**CARDINAL FREEMAN VILLAGE
137 Victoria Street, Ashfield**

**CONCEPT PLAN APPLICATION
MP 08_0245**

RESPONSE TO SUBMISSIONS REPORT

**Prepared for
Aevum Limited**

9.8m FIRETRUCK QUEEN ST EXIT INSERT B
SCALE 1: 200

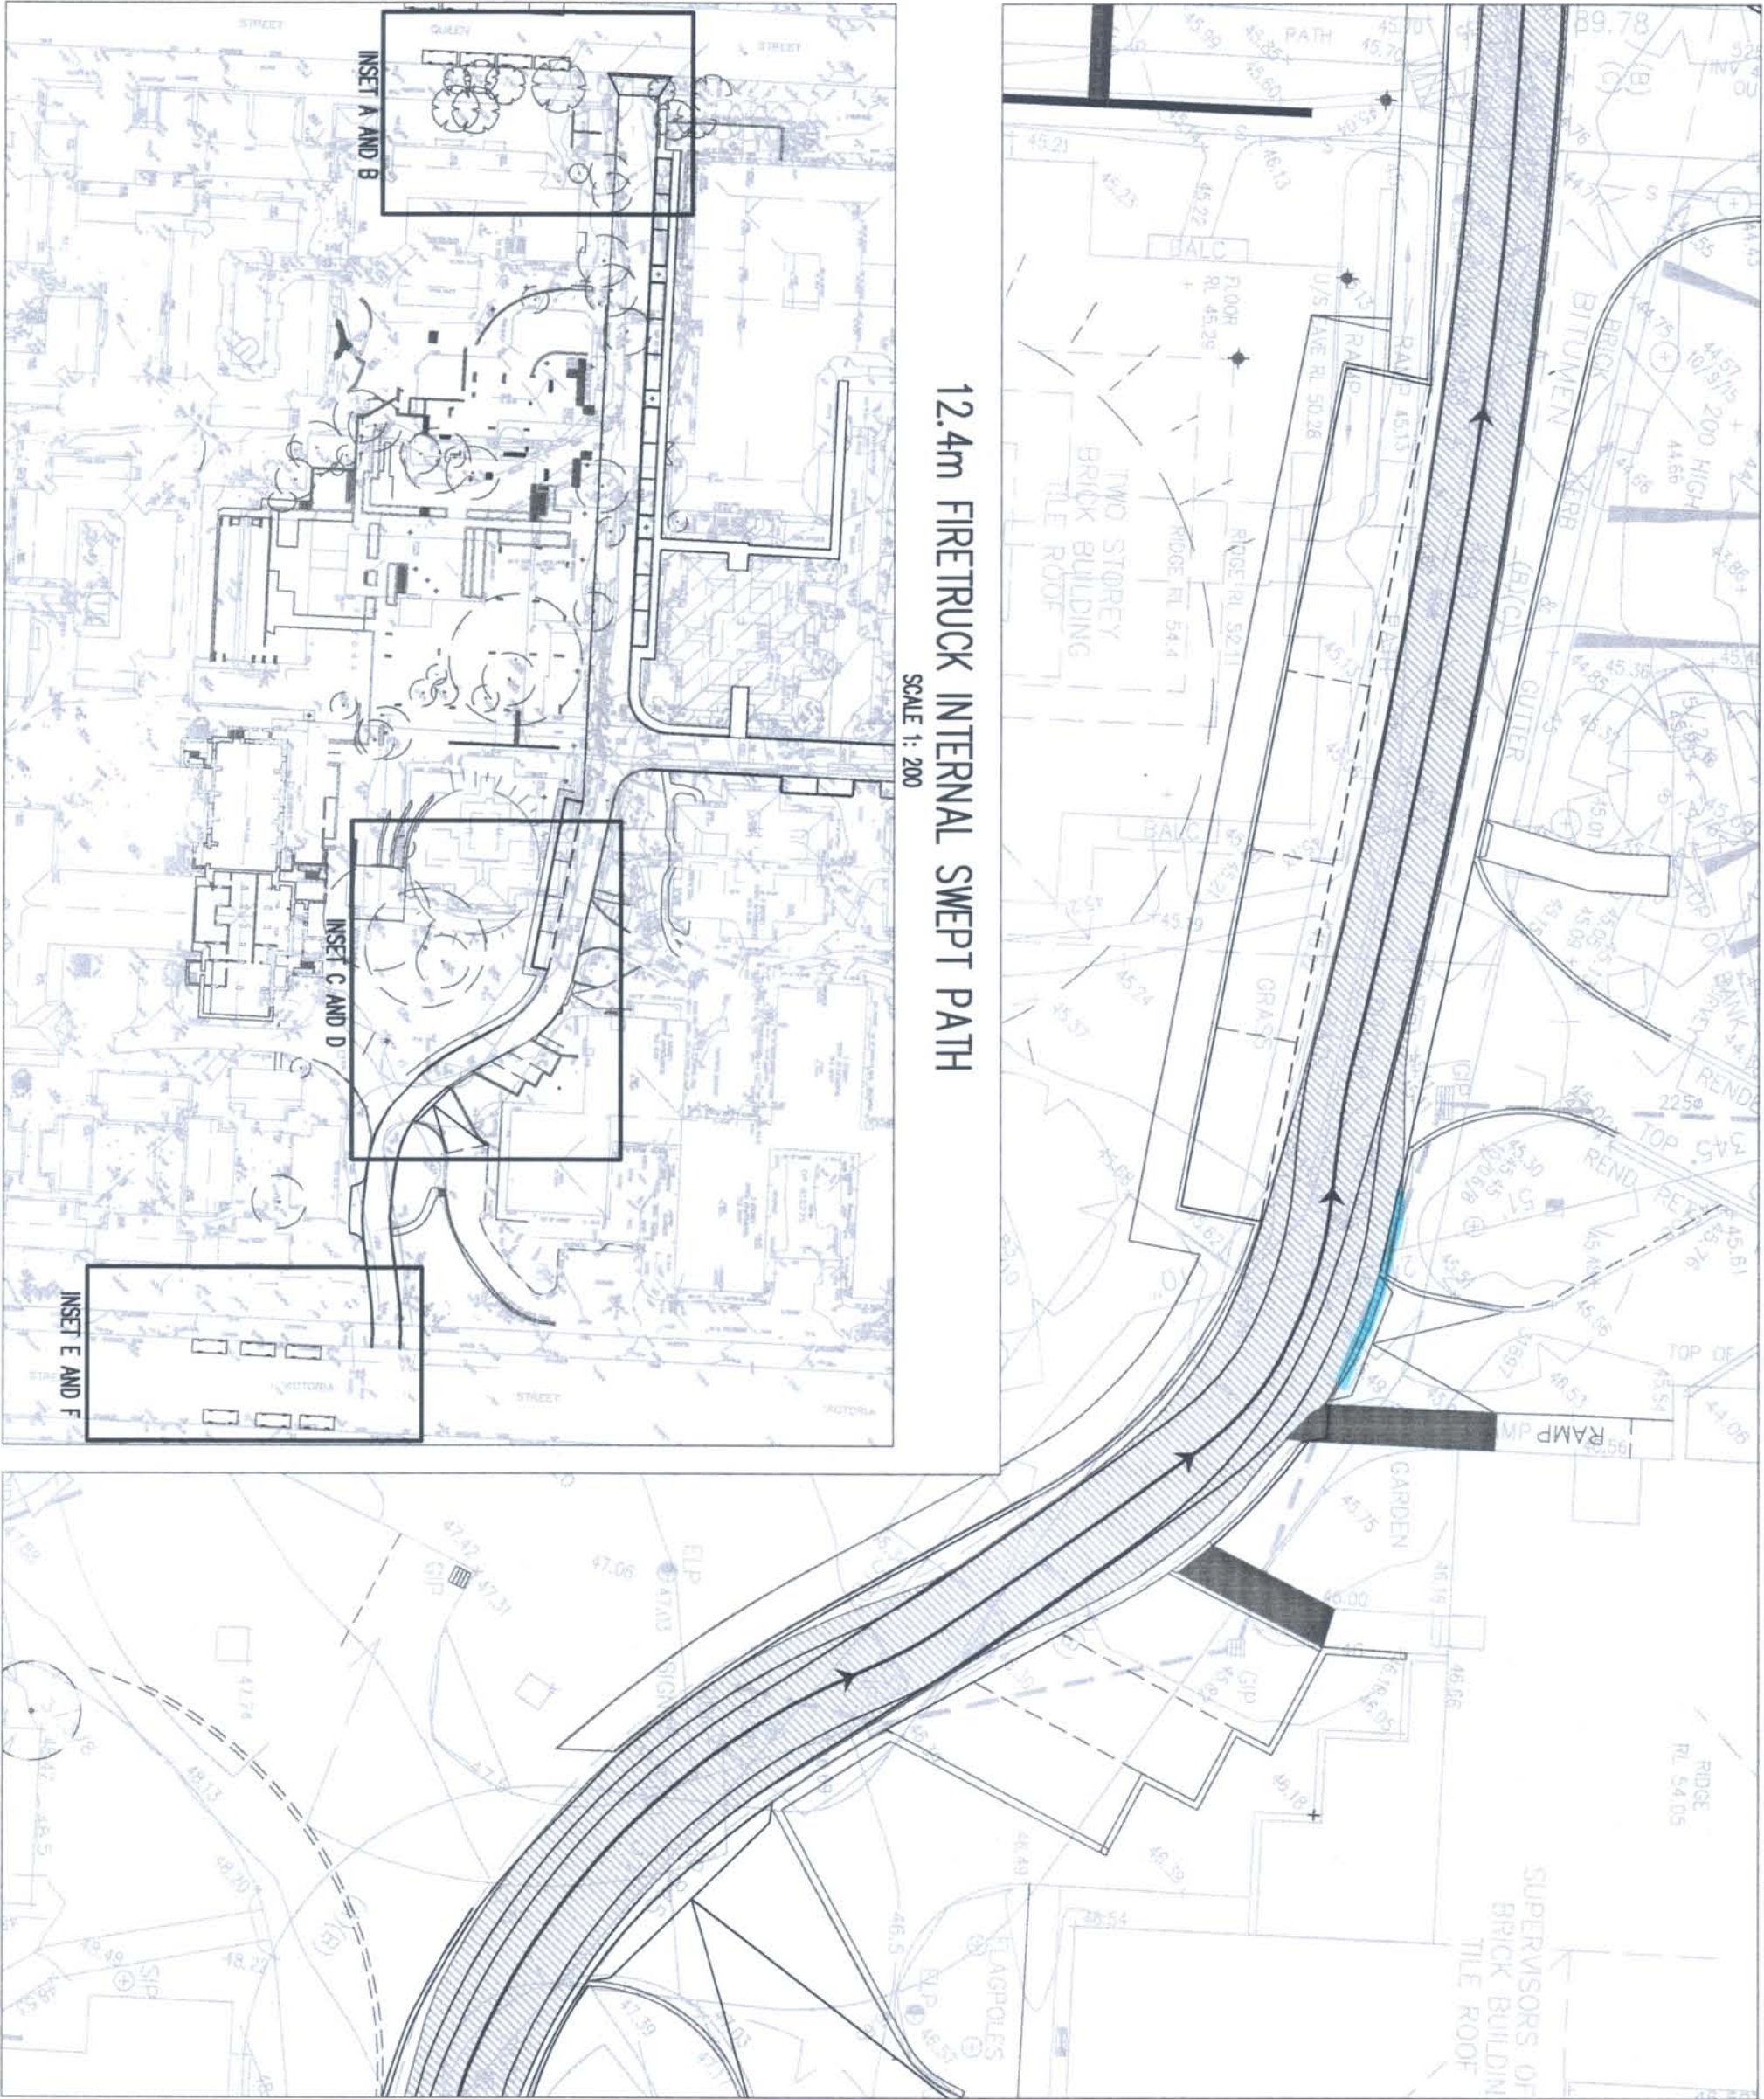
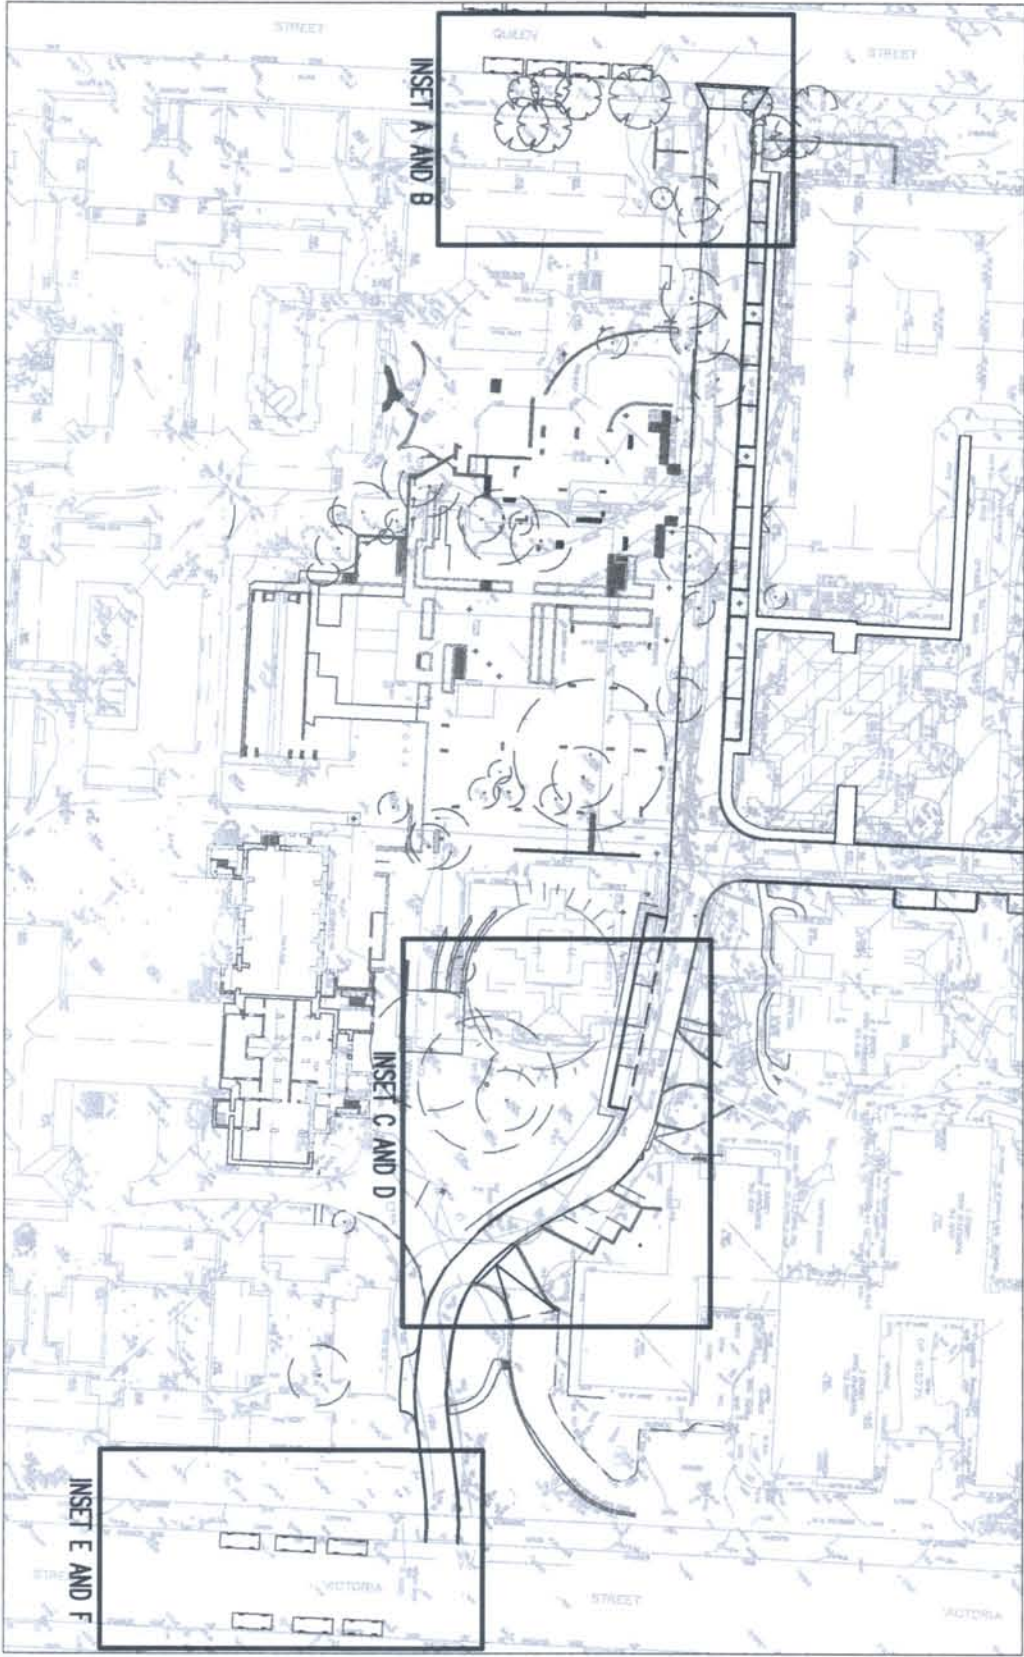
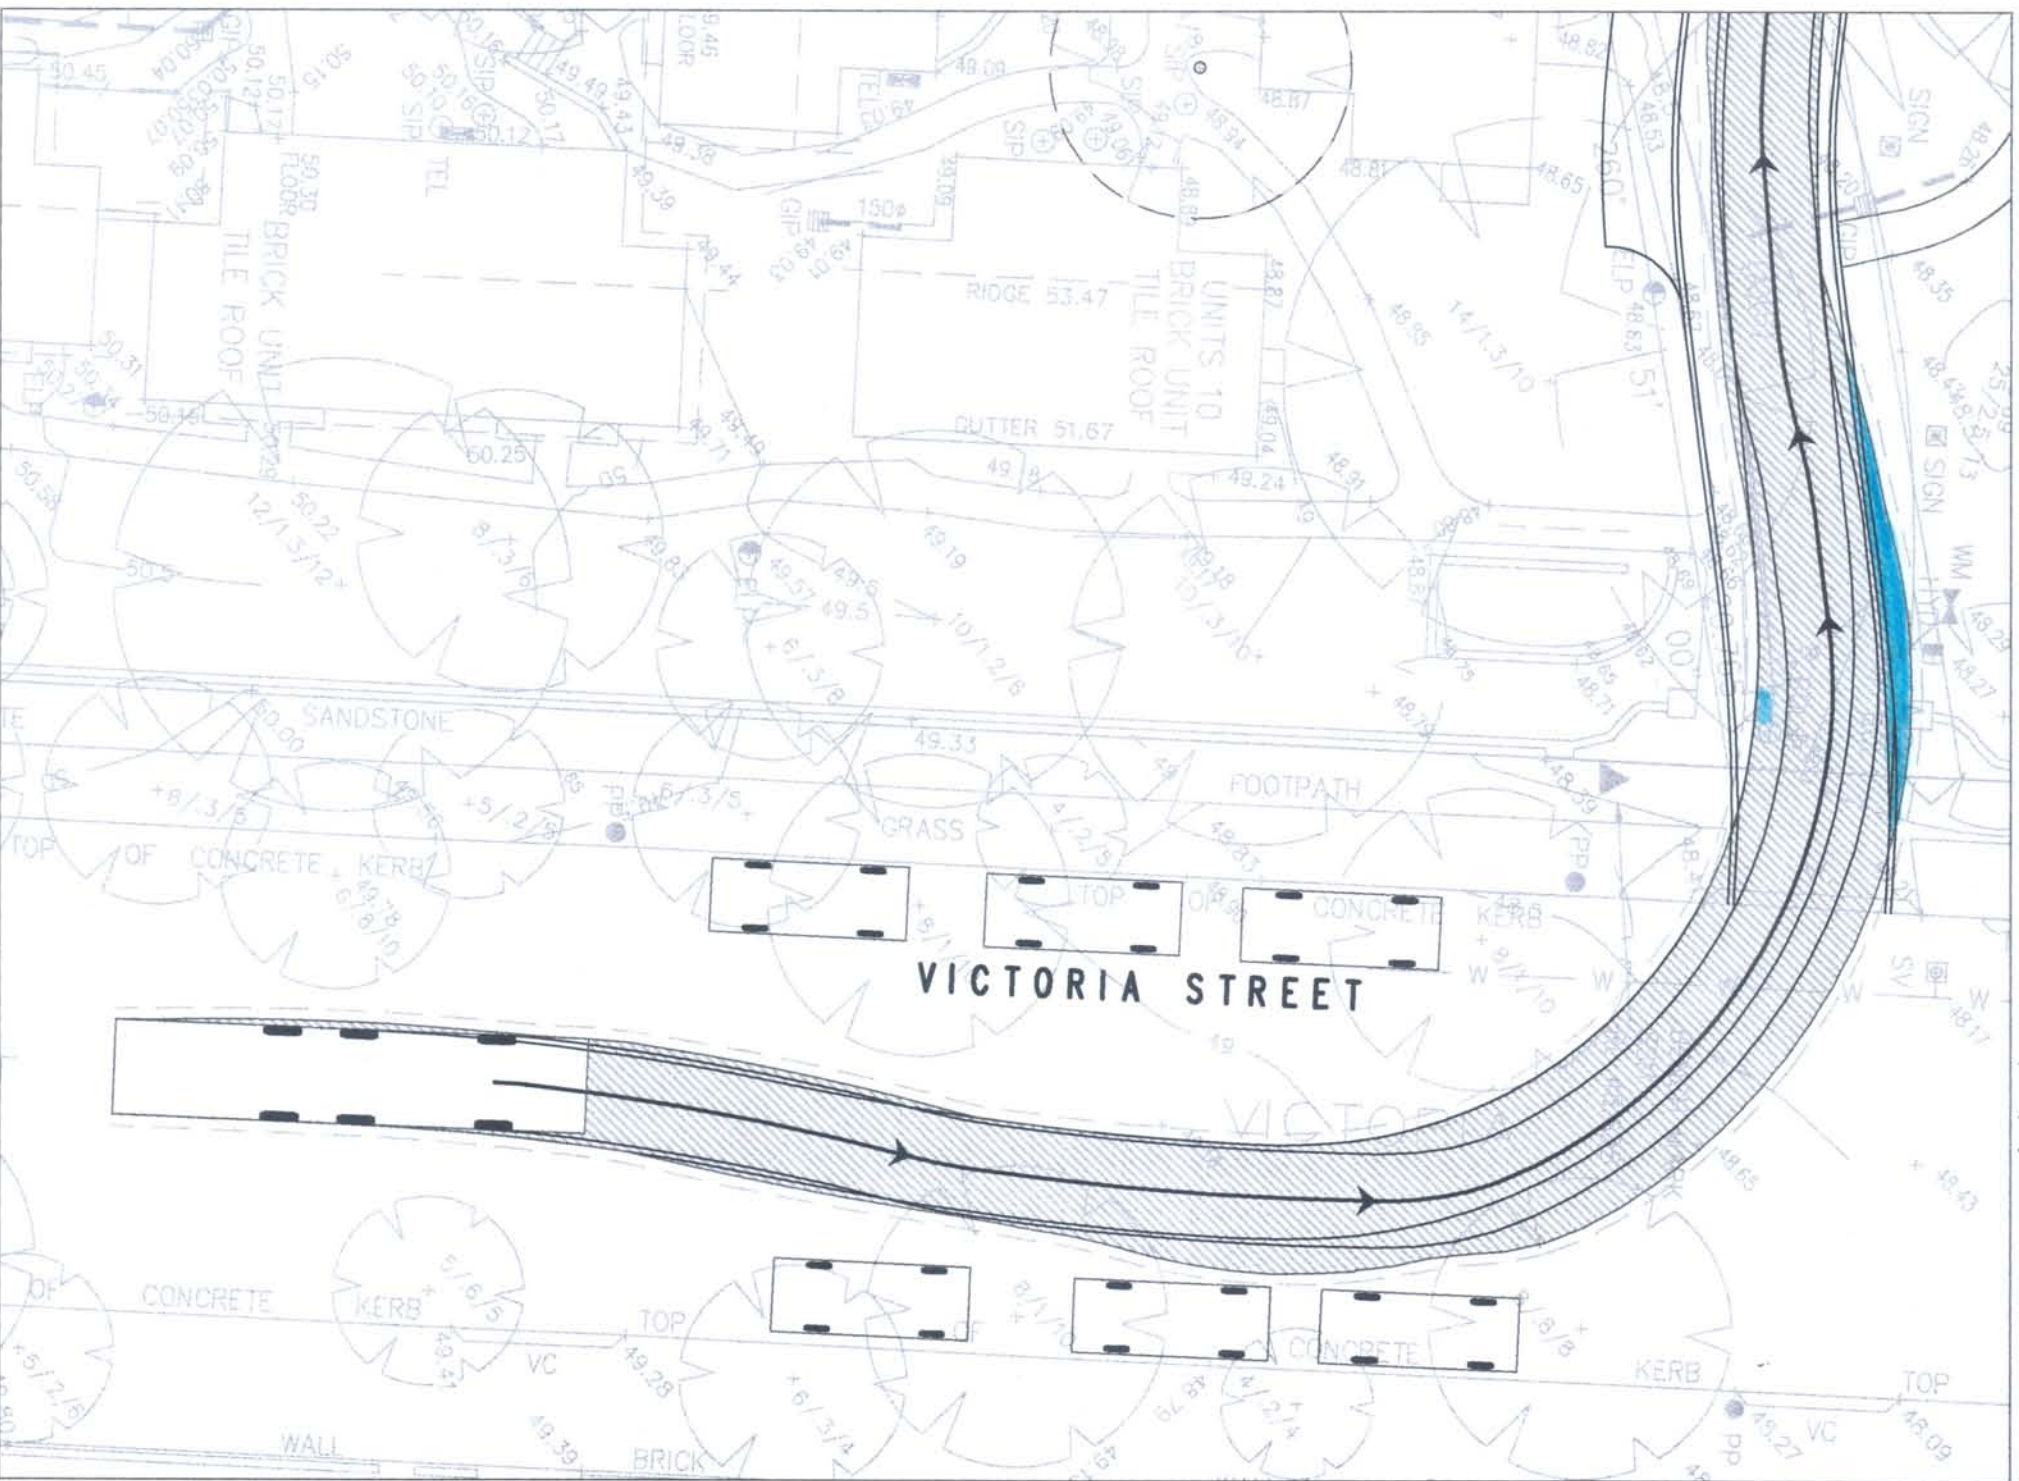
The Department has requested plans that illustrate how emergency vehicles may access the site in accordance with the NSW Fire Service Guidelines for Emergency Vehicle Access.
